RE: Oliver Shoemaker Drain

Attached is a petition and plans for the proposed relocation of the Oliver Shoemaker and John Sutton Drains. The relocation is being proposed by Mann Realty Company for a portion of the Fishers Trade Center. The proposal is to reconstruct the original 18" and 21" tiles on the West side of State road 37. Beginning at Sta 13+50 of the John Sutton Drain and Sta 75+00 of the Oliver Shoemaker Drain the drain will be routed South and East around Phase One of the Fishers Trade center and tying back into the existing tiles at Sta 20+10 of the John Sutton drain and Sta 80+50 of the Oliver Shoemaker Drain. The 48" RCP meets the requirements as set out in the drainage Study Prepared by Schneider Engineering Company dated 1996 in conjunction with the Woods of Britton Apartment project.

Re: Oliver Shoemaker Drain: Fishers Trade Center
 Phase I Relocation

STORM SEWER PLAN AND PROFILE
FISHERS TRADE CENTER
 PHASE ONE
 FISHERS, INDIANA

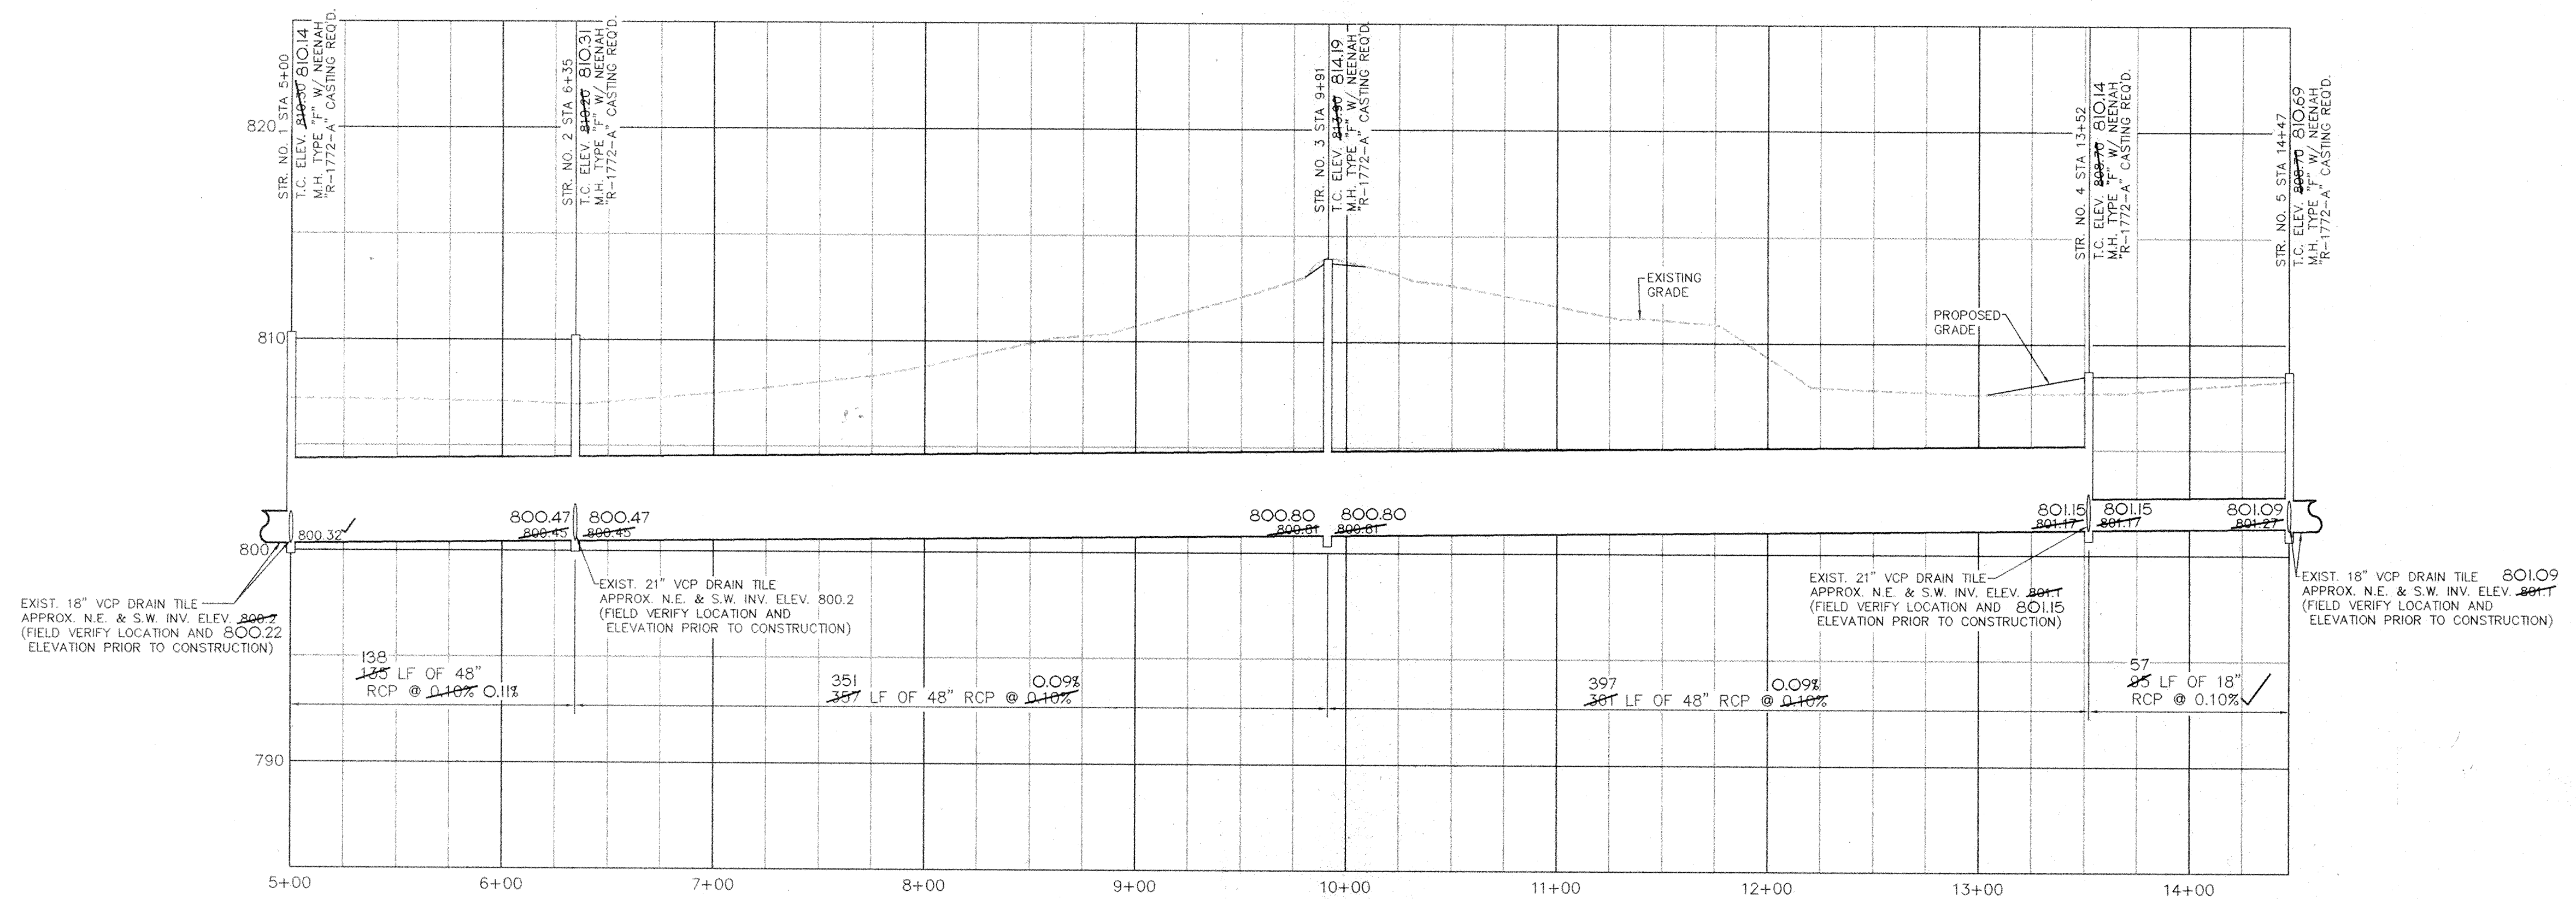
During construction, changes were made to the drain, which will alter the plans submitted with my report for this drain-dated April 23, 1999. The report was approved by the Board at the hearing held April 26, 1999. (See Drainage Board Minutes Book 5, Pages 124-125)
 The changes are as follows:

Structure:	T.C.:	I.E.:	Pipe:	Length:	Original Plans:	Difference:
5	810.69	801.09				
4	810.14	801.15	18	57	95	-38
4	810.14	801.15				
3	814.19	800.8	48	397	361	36
3	814.19	800.8				
2	810.31	800.47	48	351	357	-6
2	810.31	800.47				
1	810.14	800.32	48	138	135	3

The length of the drain due to the changes described above is now **943 feet**. There was 1210 feet of the Oliver Shoemaker and John Sutton Drains vacated with this project. Therefore, the overall drainage system was reduced by 267 feet.
